**7000Acres**

Summary statements from 7000Acres regarding matters previously raised during the examination that have not been resolved to their satisfaction.

West Burton Deadline 7 8<sup>th</sup> May 2024

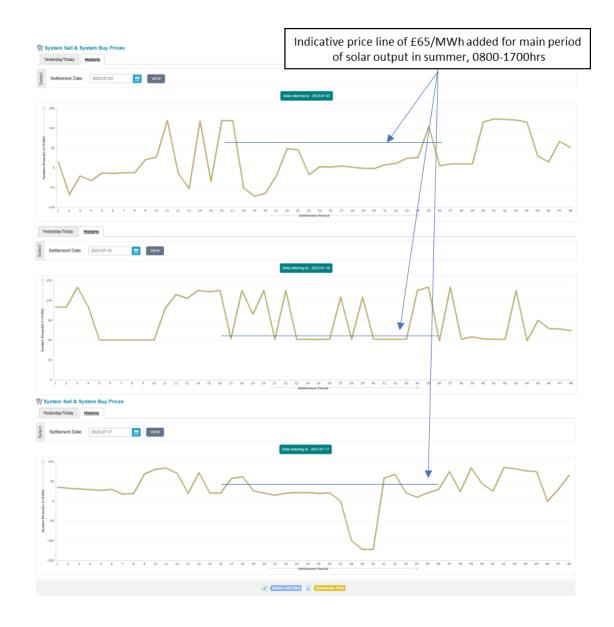
The graphs below are taken from BMReports<sup>10</sup> (website of the UK Electricity balancing and settlement market) and show the first three Mondays of July 2023 (Monday is chosen as this is frequently the highest demand day of the week) and show that system prices are

frequently significantly lower than the indexed strike price. For 03/07, the price falls to £-75 per MWh, but hovers around zero for much of the peak solar output period. For 17/07, the price plummets to £-185 per MWh, and is around £22 per MWh for much of the peak solar output period. These figures demonstrate the relatively low spot market prices of electricity during periods when solar output is at its greatest, and the relatively high cost solar will be paid during these periods, through CfD prices.

Over the same period, the weekly average prices ranged from £115 per MWHr to £125 per MWhr (Electricity Prices: Forward Delivery Contracts, Weekly Average, from Ofgem) <sup>11</sup>, which provides an indication of the much higher cost of energy during periods at other times of the day, when solar is not able to contribute to the electricity system.

This demonstrates that, while the Applicant may argue the cost of deploying solar is low, <u>the value of when the bulk of solar energy is produced in the UK, is already when prices are among their lowest, and therefore this must be considered when weighing the benefits and impacts of large-scale ground-mounted solar installation.</u>
